SUBJECT: REVIEW OF PRO IMPACT ON PUBLIC UTILITIES  
NOVI CROSSING DEVELOPMENT

Novi Crossing PRO/Conceptual  
SP #10-06

SUBJECT: Novi Crossing, Conceptual PRO and Rezoning,  
SP#10-06 / ZCM#10-0007 / RZ#18.696, Traffic Review

Figure 1. Wetland and "existing low area" north of 10-Mile road, looking north (ECT, February 12, 2010)

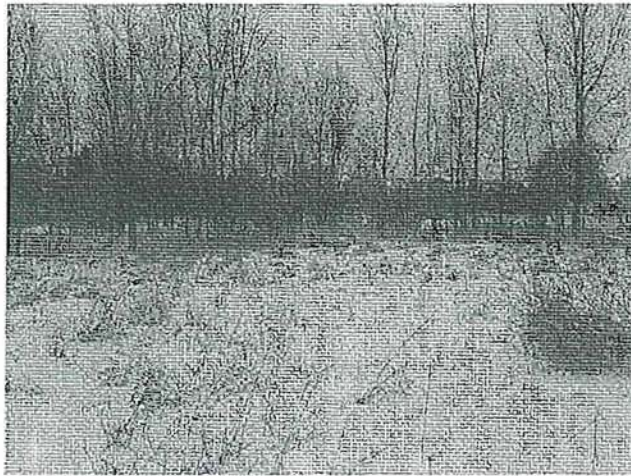
The proposed project site is mostly idle field with scattered shrubs and a few trees. One small wetland (Figure 1) was found near 10-Mile Road in an area labeled on the Plan as "existing low area." Although a few old "flags," likely several years old, were observed around the wetland, it did not appear that the wetland had been flagged recently. ECT interpreted the lack of wetland flags and the "existing low area" designation on the Plan as indication the applicant does not consider the area wetland.

I noted vegetation in the "existing low area" along with observations of the soils and wetland hydrology. Based on Michigan DNRE (DNRE) three-parameter wetland criteria, including a predominance of hydrophytic vegetation, hydric soils, and wetland hydrology indicators, I believe a small wetland does exist on the site, approximately 60-feet in diameter, or less than 4,000 square feet (0.10-acre) (Figure 2). Dominant vegetation includes reed canary grass (*Phalarus arundinaceae*), common reed (*Phalarus arundinaceae*), and a small clump of black willow (*Salix nigra*). Hydric soils consisted of mucky loam, containing high organic matter content, and oxidized roots met a primary wetland hydrology criterion.
